CITY LINK TRUCKING N. CURTIS RD. COLORADO SPRINGS, CO SITE DEVELOPMENT PLAN

SHEET INDEX					
NUMBER SHEET NAME					
DP-1	SITE PLAN				
DP-2	ENLARGED SITE PLAN

PPR2339

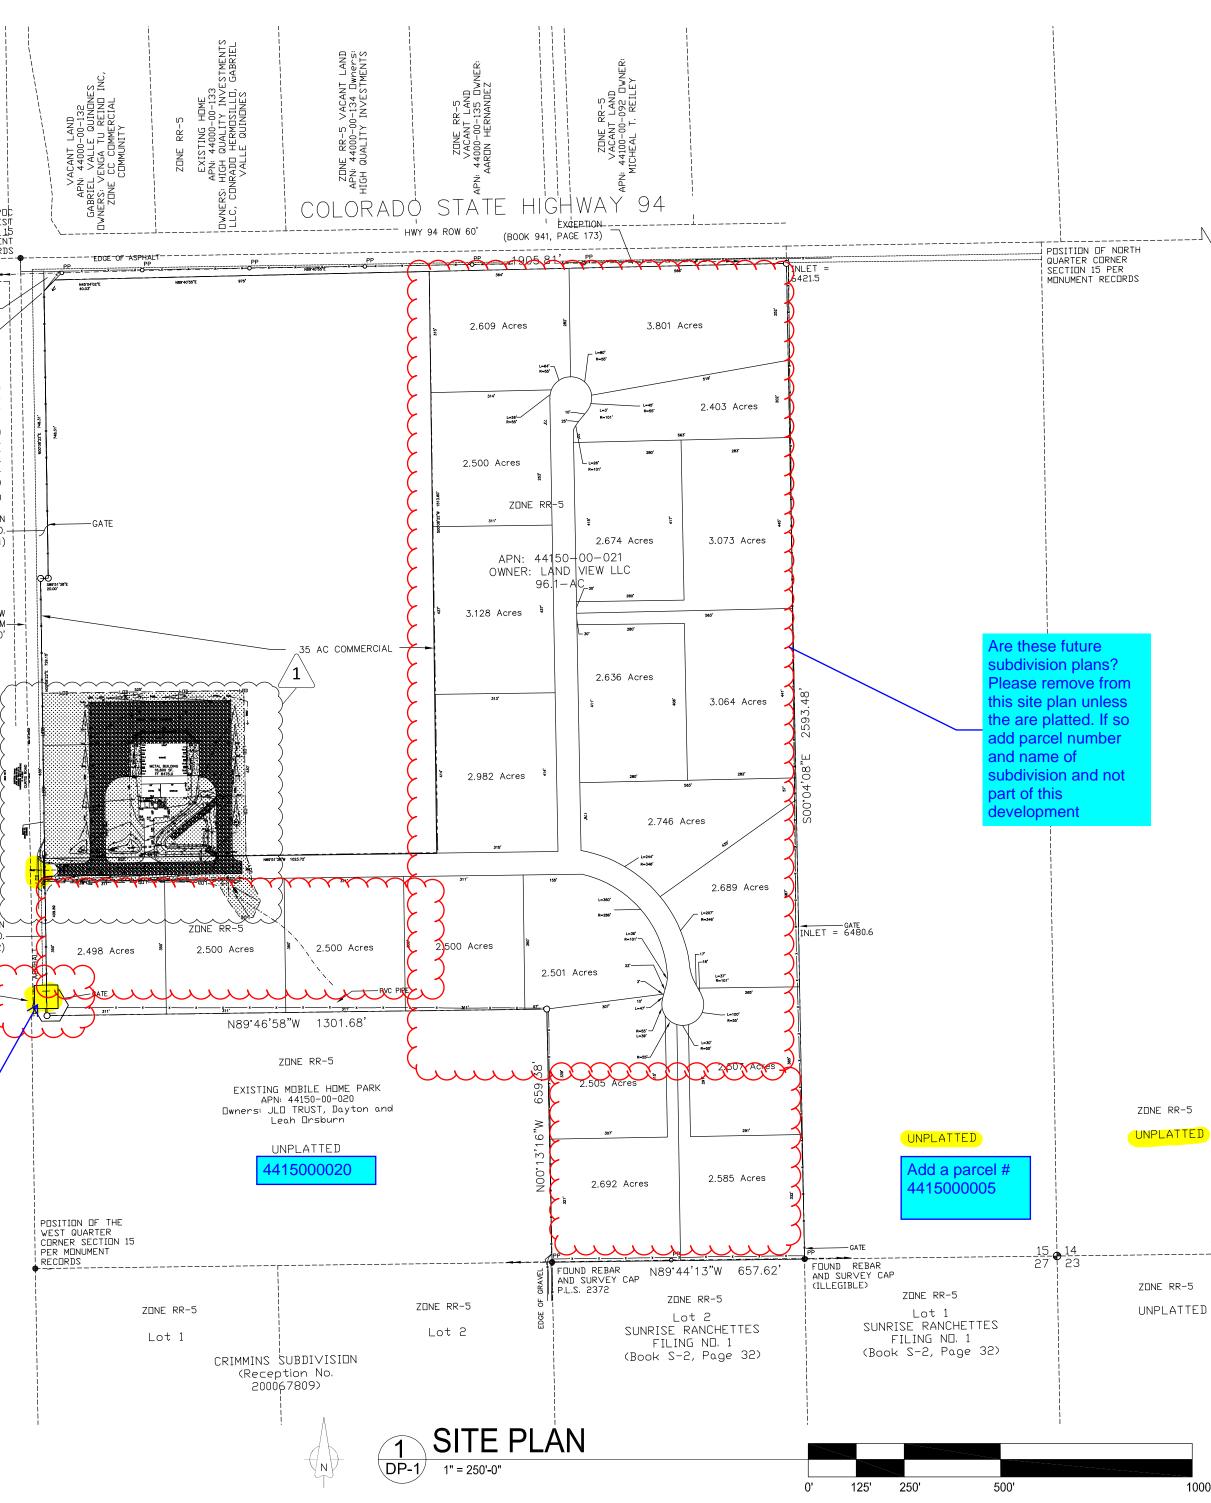
PARKING R OFFICE: TOTAL REC PROVIDED:	ABLE SURFACE: EQUIREMENTS: 1 PARKING SPAC QUIRED: 6 PARKING C 6 PARKINGS SPAC LEGEND: C C C C C C C C C C C C C C C C C C C	102,947 SF (2.4% OF LOT) E PER 300 SF; 1,750SF/300 = 6 PARKING SPACES S SPACES REQUIRED / 1 ADA PARKING SPACE REQUIRED ES / 1 ADA PARKING SPACES BOUNDARY MONUMENT FOUND (MARKED AS NOTED) TEST BORE CABLE TV PEDESTAL ELECTRIC METER ELECTRIC TRANSFORMER ELECTRIC VAULT ELECTRIC LIGHT POLE SANITARY SEWER MANHOLE TELEPHONE PEDESTAL FIRE HYDRANT CHAIN LINK FENCE	Please contact the review engineer to clarify access plan on	PDB EXCEPTION 203085 WDTH IN IN CHANGES F 60' TO EXCEPTION 2031086
PARKING R OFFICE: TOTAL REC PROVIDED: SYMBOL	ABLE SURFACE: EQUIREMENTS: 1 PARKING SPACE QUIRED: 6 PARKING 6 PARKINGS SPACE LEGEND: 0 C C C C C C C C C C C C C C C C C C	102,947 SF (2.4% OF LOT) E PER 300 SF; 1,750SF/300 = 6 PARKING SPACES G SPACES REQUIRED / 1 ADA PARKING SPACE REQUIRED ES / 1 ADA PARKING SPACES BOUNDARY MONUMENT FOUND (MARKED AS NOTED) TEST BORE CABLE TV PEDESTAL ELECTRIC METER ELECTRIC TRANSFORMER ELECTRIC LIGHT POLE SANITARY SEWER MANHOLE TELEPHONE PEDESTAL FIRE HYDRANT CHAIN LINK FENCE UNDERGROUND SANITARY SEWER	Please contact the review engineer to clarify access plan on the site dev plan	PDB C C C C C C C C C C C C C C C C C C C

PARKING R OFFICE: TOTAL REC PROVIDED: SYMBOL	ABLE SURFACE: EQUIREMENTS: 1 PARKING SPAC QUIRED: 6 PARKING 6 PARKINGS SPAC C C C C C C C C C C C C C C C C C C	102,947 SF (2.4% OF LOT) E PER 300 SF; 1,750SF/300 = 6 PARKING SPACES G SPACES REQUIRED / 1 ADA PARKING SPACE REQUIRED ES / 1 ADA PARKING SPACES BOUNDARY MONUMENT FOUND (MARKED AS NOTED) TEST BORE CABLE TV PEDESTAL ELECTRIC METER ELECTRIC TRANSFORMER ELECTRIC TRANSFORMER ELECTRIC VAULT ELECTRIC LIGHT POLE SANITARY SEWER MANHOLE TELEPHONE PEDESTAL FIRE HYDRANT CHAIN LINK FENCE UNDERGROUND SANITARY SEWER UNDERGROUND CABLE TV LINE UNDERGROUND GAS LINE UNDERGROUND TELEPHONE LINE	Please contact the review engineer to clarify access plan on the site dev plan	PUB (C C C C C C C C C C C C C C C C C C
PARKING R OFFICE: TOTAL REC PROVIDED: SYMBOL	ABLE SURFACE: EQUIREMENTS: 1 PARKING SPAC QUIRED: 6 PARKINGS SPAC LEGEND: •	102,947 SF (2.4% OF LOT) E PER 300 SF; 1,750SF/300 = 6 PARKING SPACES G SPACES REQUIRED / 1 ADA PARKING SPACE REQUIRED ES / 1 ADA PARKING SPACES BOUNDARY MONUMENT FOUND (MARKED AS NOTED) TEST BORE CABLE TV PEDESTAL ELECTRIC METER ELECTRIC TRANSFORMER ELECTRIC TRANSFORMER ELECTRIC LIGHT POLE SANITARY SEWER MANHOLE TELEPHONE PEDESTAL FIRE HYDRANT CHAIN LINK FENCE UNDERGROUND SANITARY SEWER UNDERGROUND CABLE TV LINE UNDERGROUND GAS LINE UNDERGROUND GAS LINE	Please contact the review engineer to clarify access plan on the site dev plan This side access road requires more detail and is not provided in the CD or GEC plan. One point of access is permitted to Curtis Road a MCTP	PDB C C C C C C C C C C C C C C C C C C C

PARKING R OFFICE: TOTAL REC PROVIDED: SYMBOL	ABLE SURFACE: EQUIREMENTS: 1 PARKING SPAC QUIRED: 6 PARKINGS SPAC LEGEND: •	102,947 SF (2.4% OF LOT) E PER 300 SF; 1,750SF/300 = 6 PARKING SPACES S SPACES REQUIRED / 1 ADA PARKING SPACE REQUIRED ES / 1 ADA PARKING SPACES BOUNDARY MONUMENT FOUND (MARKED AS NOTED) TEST BORE CABLE TV PEDESTAL ELECTRIC METER ELECTRIC TRANSFORMER ELECTRIC VAULT ELECTRIC LIGHT POLE SANITARY SEWER MANHOLE TELEPHONE PEDESTAL FIRE HYDRANT CHAIN LINK FENCE UNDERGROUND SANITARY SEWER UNDERGROUND CABLE TV LINE UNDERGROUND ELECTRIC LINE UNDERGROUND GAS LINE UNDERGROUND TELEPHONE LINE UNDERGROUND WATER LINE	Please contact the review engineer to clarify access plan on the site dev plan This side access road requires more detail and is not provided in the CD or GEC plan. One point of access is permitted to Curtis Road a MCTP designated minor arterial. The private	PDB C C C C C C C C C C C C C C C C C C C
